City of Portland, Maine – Building or Use Permit Application 389 Congress Street, 04101, Tel: (207) 874-8703, FAX: 874-8716

BUILDING PERMIT REPORT

DATE: 10 MAY 2008 ADDRESS: 318 Brighton Ave CBL: 120-C-019

REASON FOR PERMIT: Repair porch Post

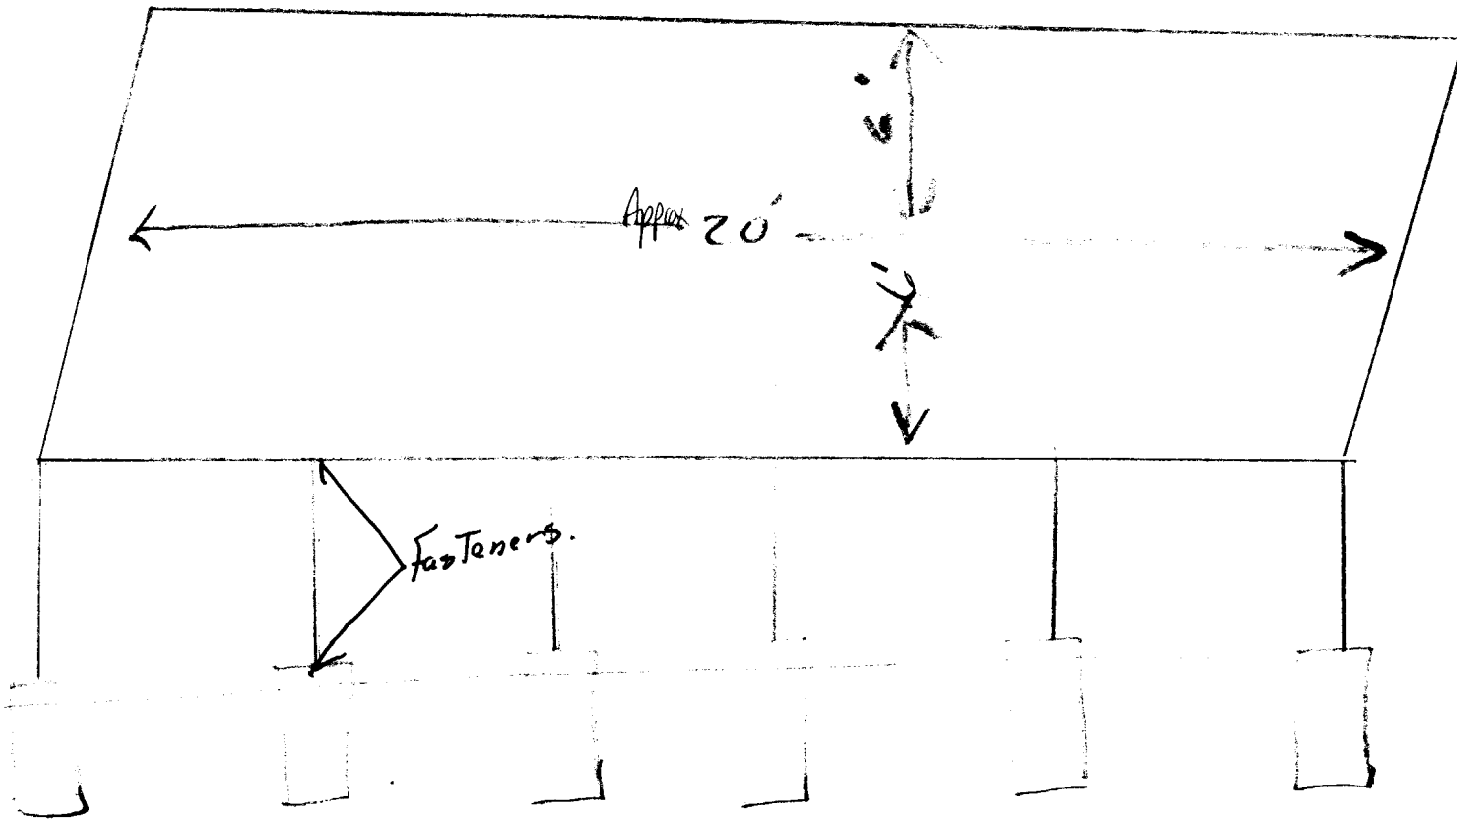
- 1.) Replace old metal posts with 6x6 pressure treated posts set on concrete which is 10" diameter 4 1/2" deep.
These will be placed in original holes which are 4' apart.
- 2.) ORIGINAL Joists are still good - But we want to sister pressure treated 2" x 8" x 6' ^{Approx} 16" ON CENTER
There are 20 Joists. Sistering the first 6'.

35. All signage, shall be done in accordance with Section 3102.0 signs of the City's Building Code, (The BOCA National Building Code/1999).
- * 36. Fasteners shall be used between piers and 6x6" and the 6"x6" and porch Framing

- * 37. The proposed 10" piers shall be placed on Footings with anchors or on ledge.
- * 38. Not to Exceed an existing footprint
